ASHGROVE ROAD, SEVENOAKS

Proposed Field Access

Stage 1 Road Safety Audit
Requested by Motion Consultants

Gateway TSP ref: WP/JS/2008028 RSA1 v1.0

Drawing:
2008028-02

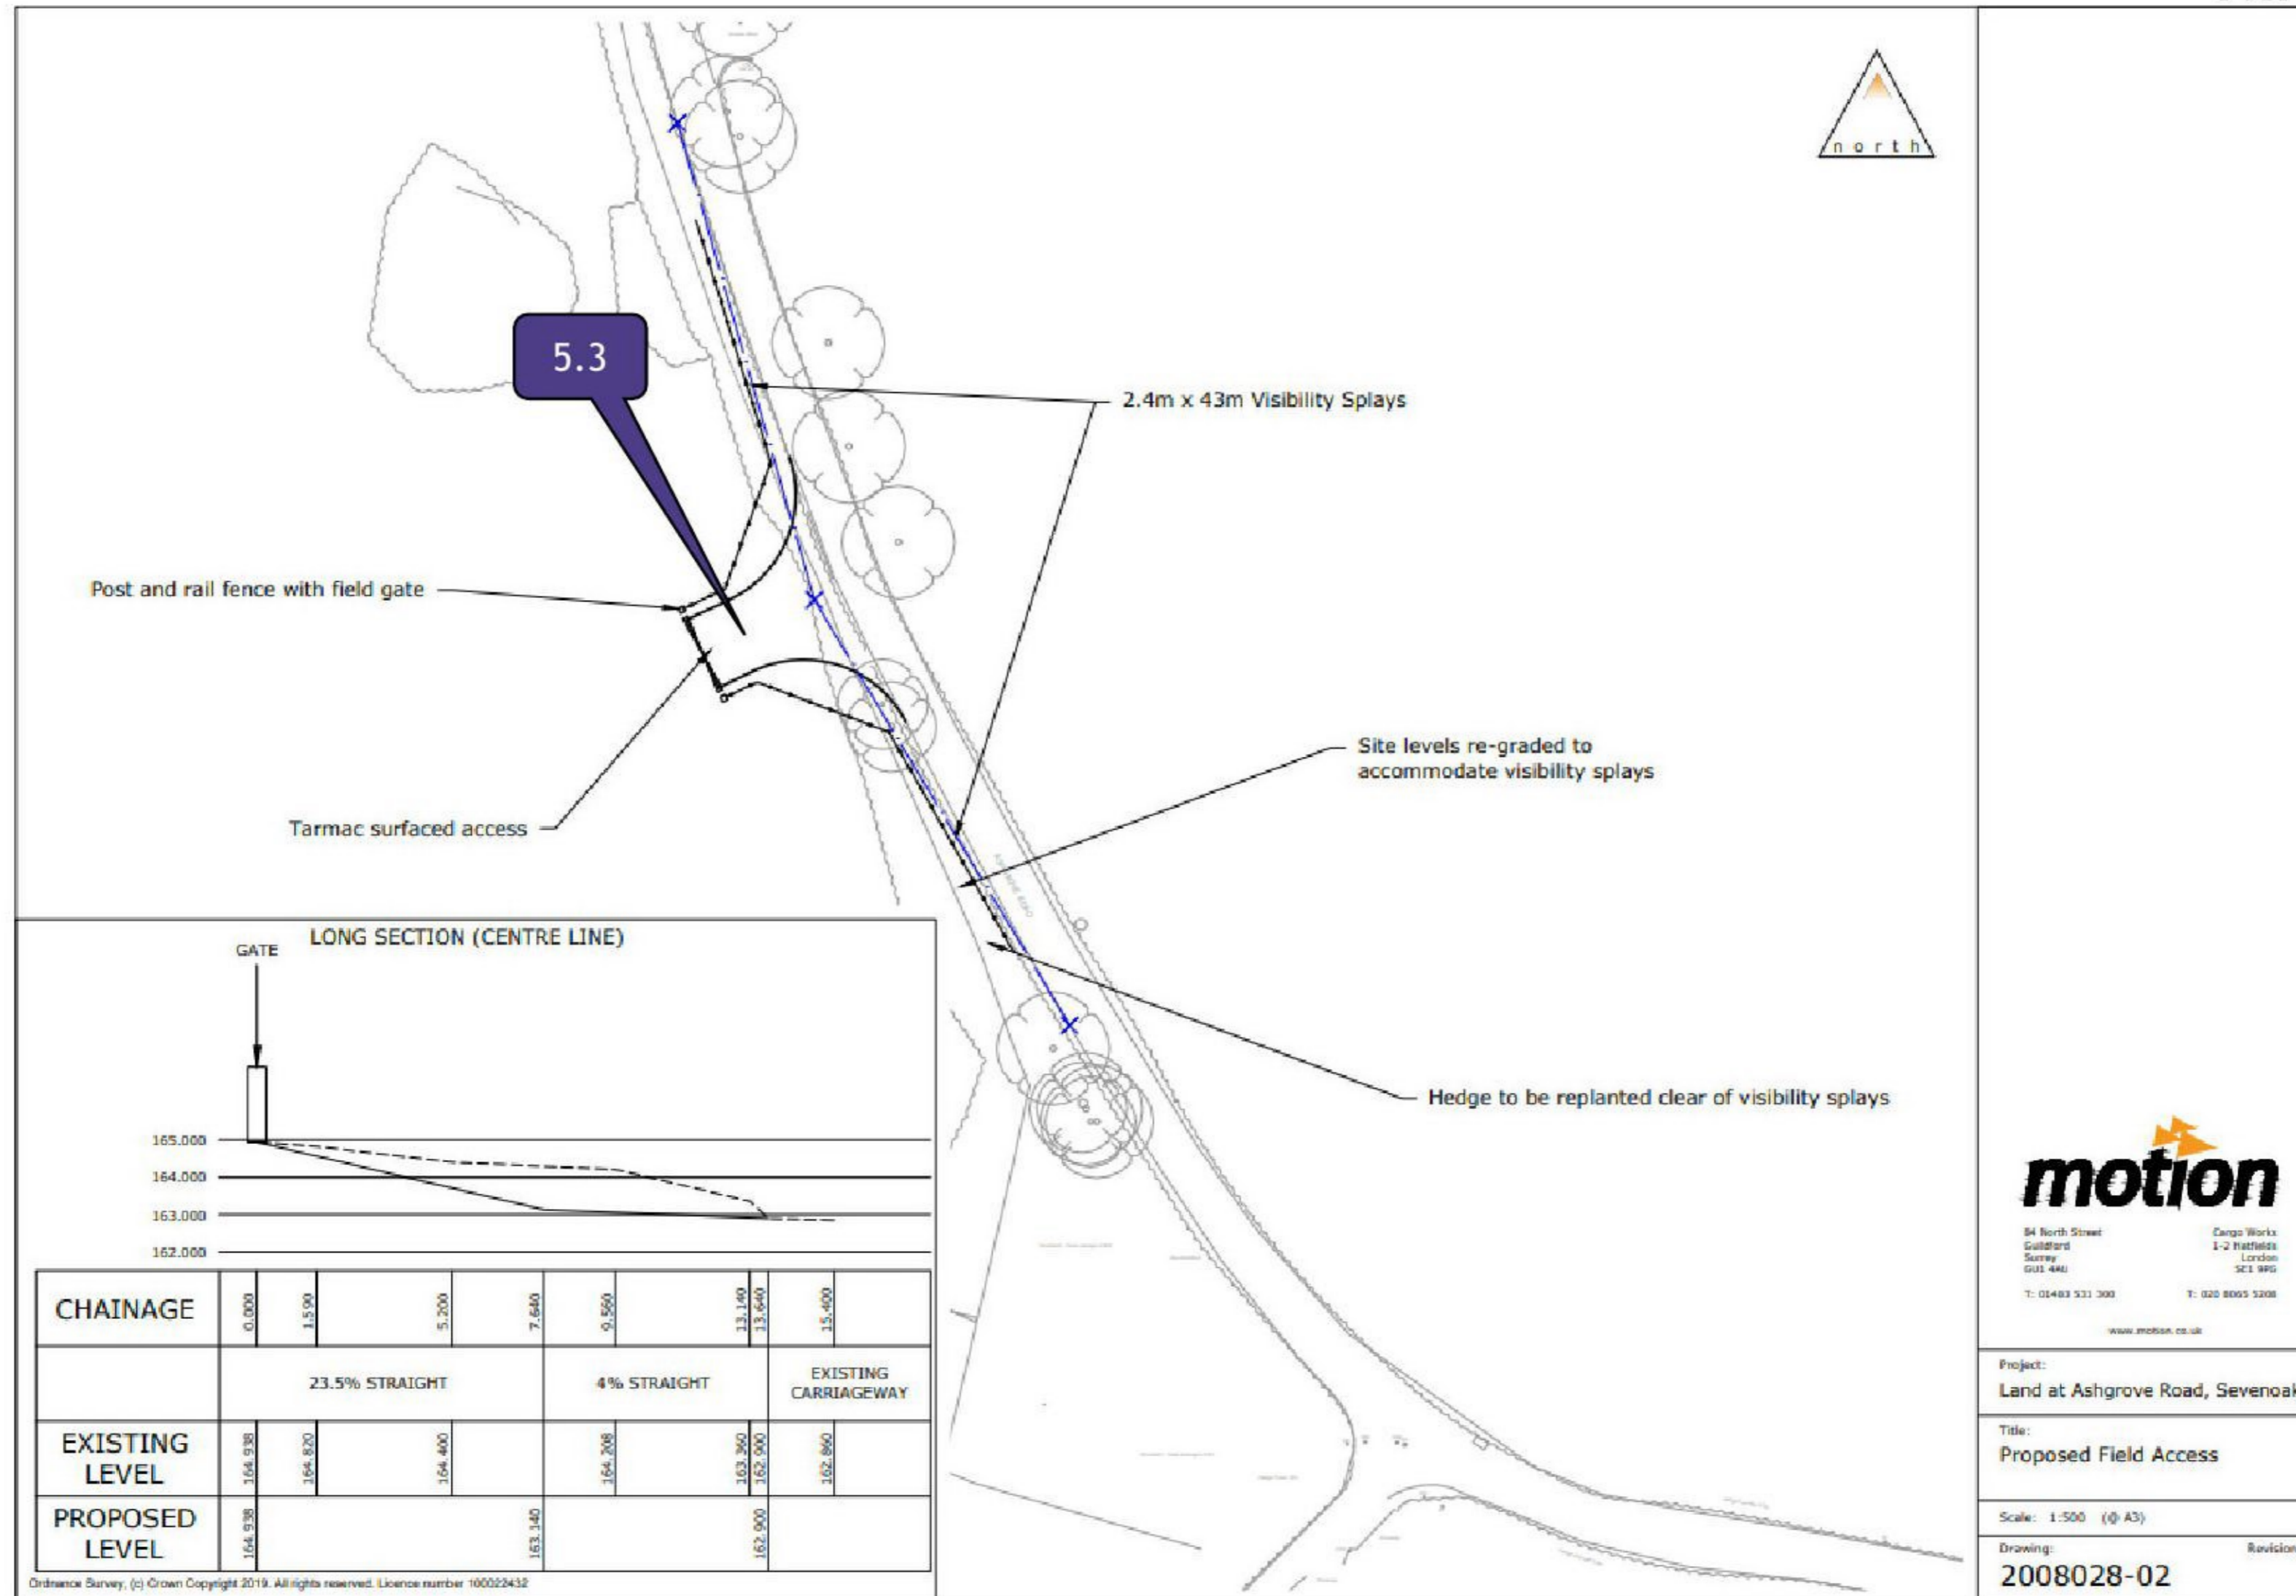
Steep gradient may lead to loss of control vehicle collisions

Location: Field access

The proposed access rises from the carriageway, steepening up to 23.5% in front of the gate. This steep gradient may result in vehicles losing control when using the access during icy or muddy conditions, or inadvertently rolling towards the carriageway when stopping/starting to open or close the gate; this may lead to T bone collisions at the access. Furthermore, pedestrians may suffer slips and falls on the steep gradient when stepping out of their vehicles to open or close the gate.

The steep gradient at the access should be slackened.
